# RN SERIES TECHNICAL BULLETIN

ISSUE NO. : RNT-005

## SUBJECT: 021-18117-207 Guide Tip; Master Loading

### Newly-registered Part
021-18117-207 Guide Tip; Master Loading

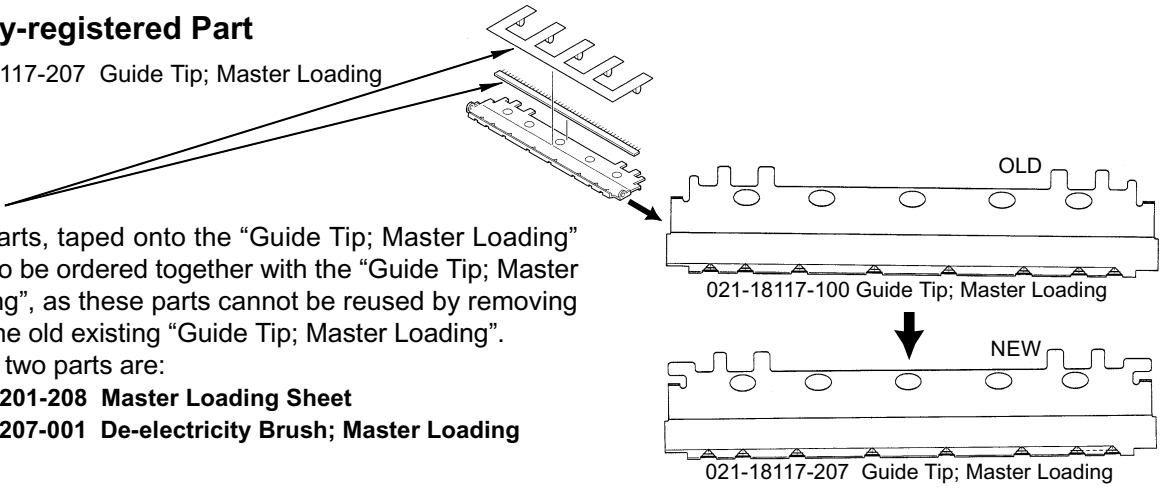
### Brief:
The shape of the "Guide Tip; Master Loading" was changed.

### Reason:
Curled master had tendency to clamp under the Clamp Plate of the Drum with the tips on both ends folded. This resulted in master disposal error, as the folded portion of the master at the leading edge hesitated from entering into the master disposal area.

### Modification:
The both ends at the tip of the "Guide Tip; Master Loading" were extended out to prevent the front tip corners of the master material to curl and end up folding under the Clamp Plate.

**Note:**
Two parts, taped onto the "Guide Tip; Master Loading" need to be ordered together with the "Guide Tip; Master Loading", as these parts cannot be reused by removing from the old existing "Guide Tip; Master Loading".
These two parts are:
**021-18201-208 Master Loading Sheet**
**021-18207-001 De-electricity Brush; Master Loading**
